Technical Service Information

THM 3T40 (125C) RE-DESIGNED FORWARD CLUTCH PACK

Figure 1

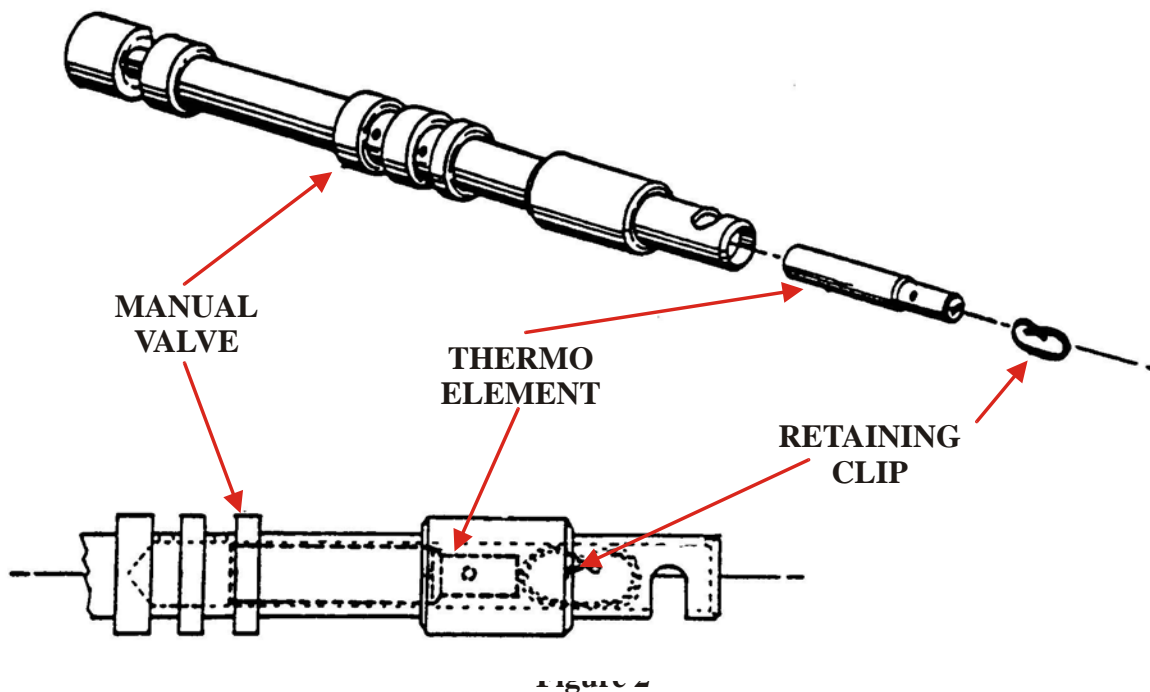
REASON: Improved garage shift from "Reverse to Drive" after removal of the thermo element from the manual valve. The thermo element was eliminated from the manual valve in production models effective April 1, 1993, on all models except "A" Car and "T" Car applications (See Figure 1).

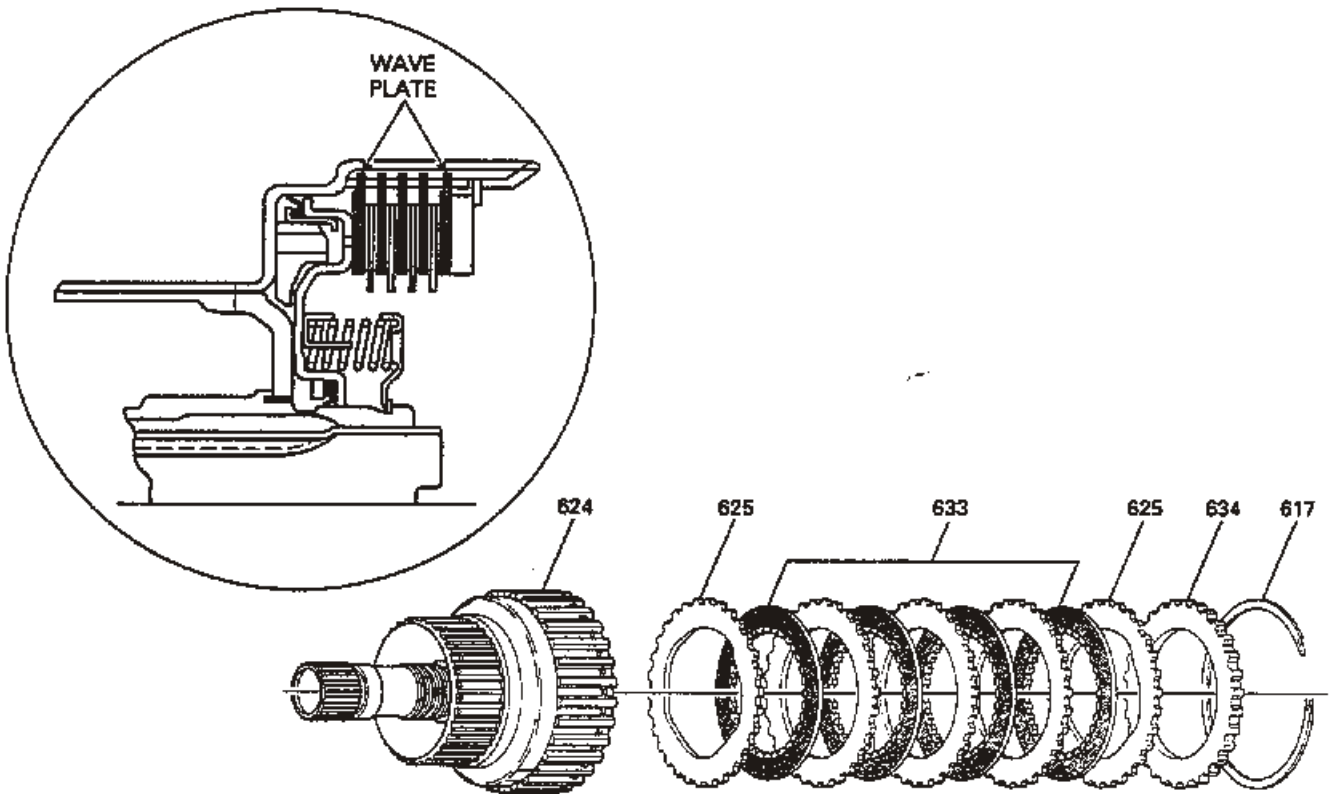
CHANGE: Beginning June 24, 1993 (Julian Date 154) ALL 3T40 (125C) transaxles were built with a re-designed Forward Clutch Pack, as shown in Figure 2.

(1) WAVE PLATES - The two previous "Wave" plates have been eliminated, as shown in Figure 2.

(2) BELLVILLE PLATE - Added to the forward clutch pack to replace the two wave plates, and provides more resistance to improve the forward clutch apply feel (See Figure 2).

(3) STEEL PLATE - There is one "Flat" Steel plate added next to bellville plate, as shown in Figure 2.

Figure 3

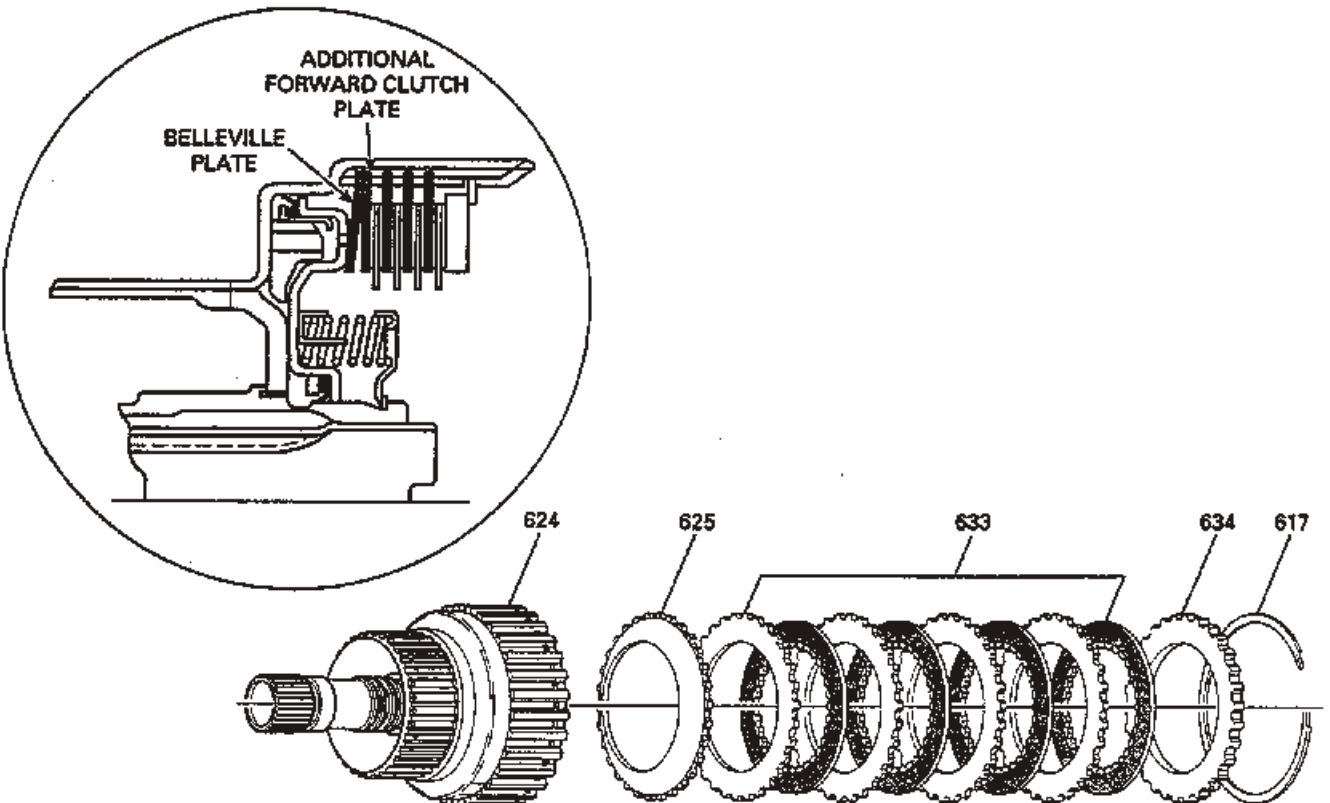
(5) BACKING PLATE SNAP RING - The backing plate snap ring used in the new design forward clutch pack is also a previous design level snap ring that is slightly larger in diameter (Stronger) than the current snap ring, to accommodate the added bellville plate. The stronger snap ring is identified with "Square" cut ends instead of "Stepped" cut ends as shown in Figure 3. The "Stepped" cut snap ring is now used ONLY in the direct clutch pack.
